## NONKEY TELEPHONE SETS

### CONVERSION FOR USE WITH 1A1 OR 1A2 KEY TELEPHONE SYSTEMS

1.001 This addendum supplements Section 502-110-102, Issue 4. Place this pink sheet ahead of Sheet 1 of this section.

Fig. 5-554BMP Telephone Set, Connections for Use With 1A1 or 1A2 KTS

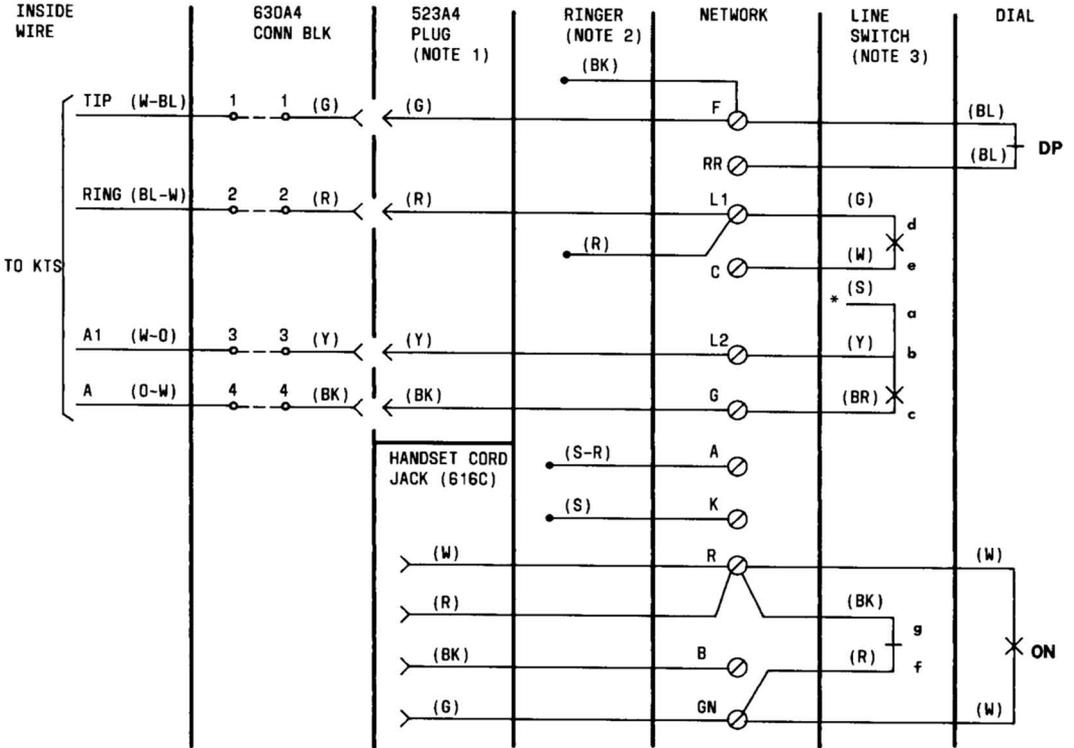
1.002 This addendum is issued to revise Fig. 5.

2.001 On Page 8 revise Fig. 5 as shown in this addendum.

1. REPLACE 523A3 PLUG WITH 523A4 PLUG, ORDERED SEPARATELY.
2. WIRED FOR INDIVIDUAL OR BRIDGED RINGING.
3. TO PREVENT FALSE HOLD CONDITION WHEN GOING ON-HOOK, THE TIP AND RING CONTACTS OF THE LINE SWITCH MUST BREAK BEFORE "A" LEAD CONTACTS. (FIELD ADJUSTMENT OF LINE SWITCH NOT RECOMMENDED).
